SUPP. DWG. NO. JP2-1

TITLE ADD ALTERNATE NO. JP-2
ARCH - EXIST STACKS/READING III

DRAWN BY	CHECKED BY	DATE	COMM. NO.
MWS	DDP	11/30/07	6501.06

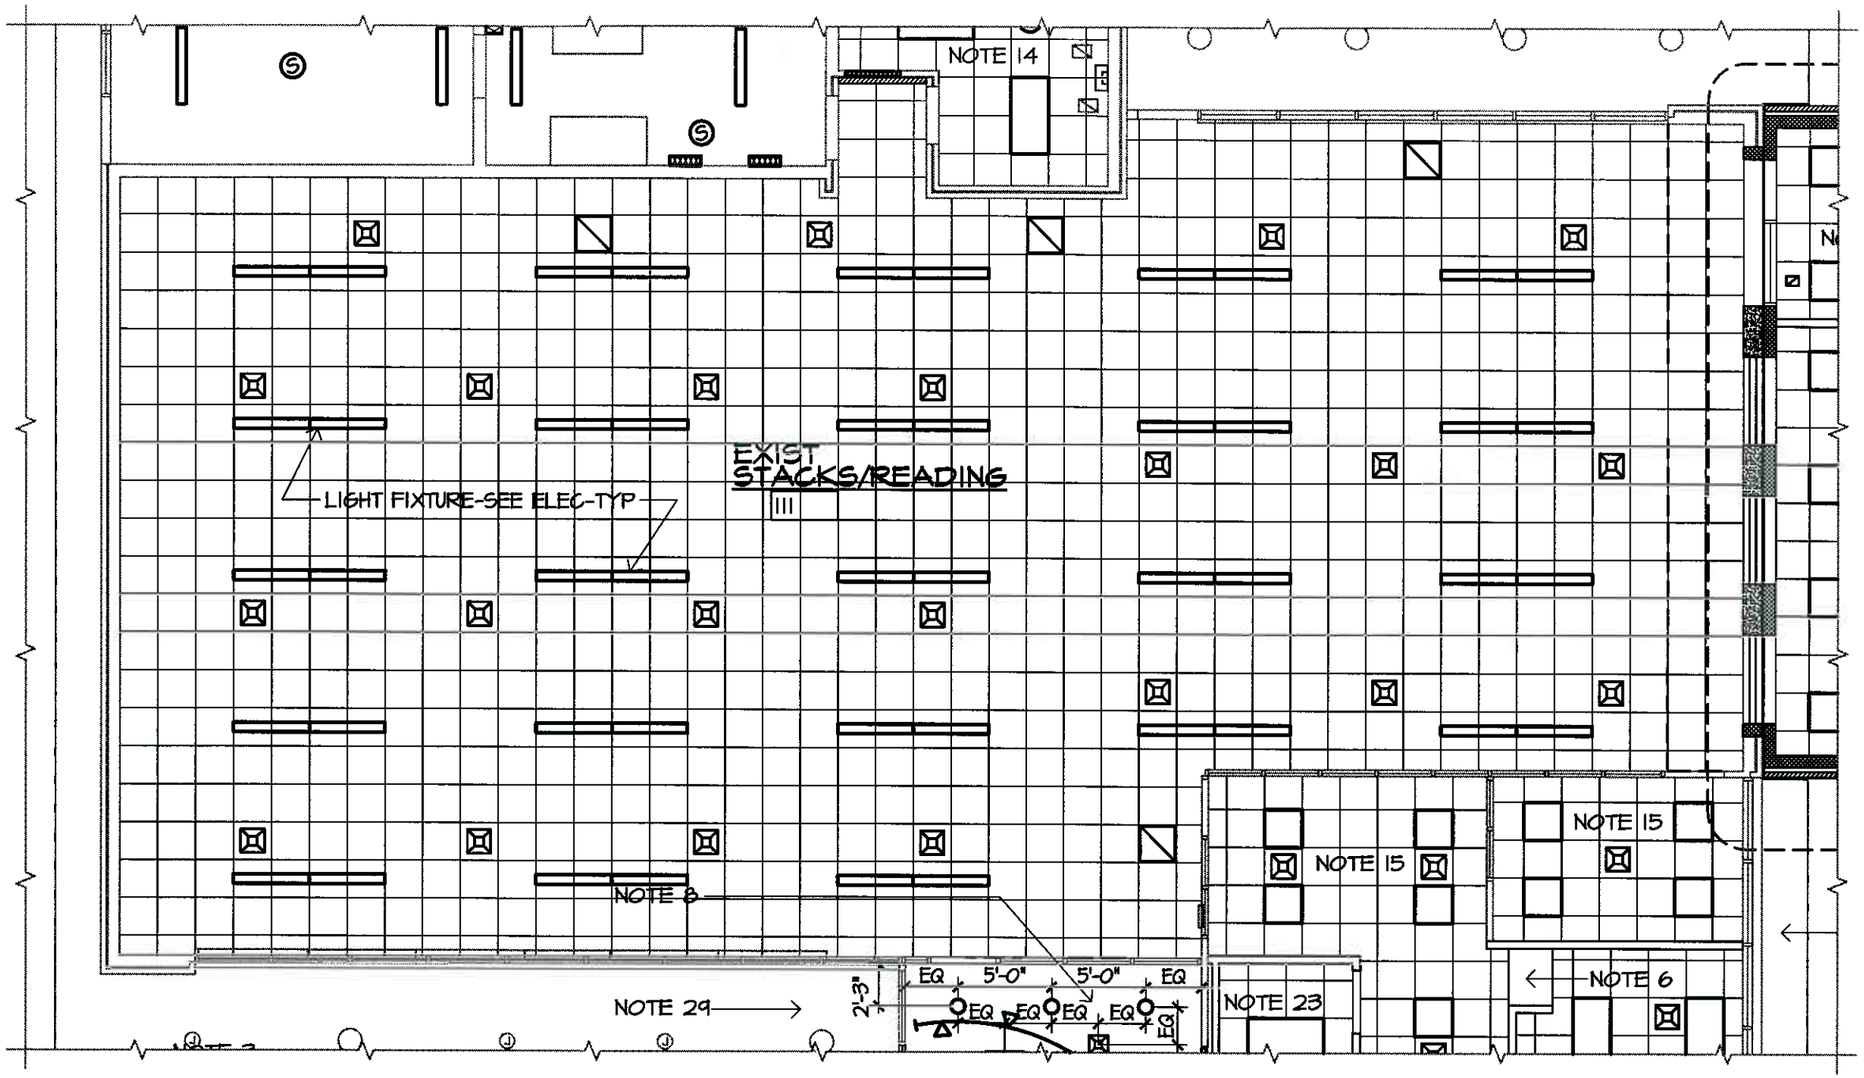
1. SCOPE OF WORK IS NEW SUSPENDED CEILING SYSTEM, NEW LIGHTING & MODIFIED MECHANICAL WORK AT EXISTING STACKS/READING III.
2. ON SHEET AD1.1 OF THE CONSTRUCTION SET, DATED OCTOBER 28, 2007, DISREGARD THE FOLLOWING "NOTES THIS SHEET": NOTE 10. ALSO DISREGARD THE HATCHED AREA THAT THE NOTE APPLIES TO.

3. ON SHEET A3.1 OF THE CONSTRUCTION SET, DATED OCTOBER 28, 2007, DISREGARD THE FOLLOWING "NOTES THIS SHEET": NOTE 4, NOTE 27. ALSO DISREGARD THE HATCHED AREA THAT NOTE 27 APPLIES TO.

4. THE EXISTING SUSPENDED CEILING SYSTEM, EXISTING LIGHT FIXTURES & EXISTING DUCT BOOTS WILL BE REMOVED BY THE OWNER.
5. SUSPENDED LAY-IN ACOUSTICAL CEILING SYSTEM SHALL BE 2'X2' TYPE I AND SHALL BE INSTALLED AT THE SAME HEIGHT AFF AS THE EXISTING CEILING (APPROX 9'-4" AFF). REFER TO SPECIFICATION SECTION 09510.
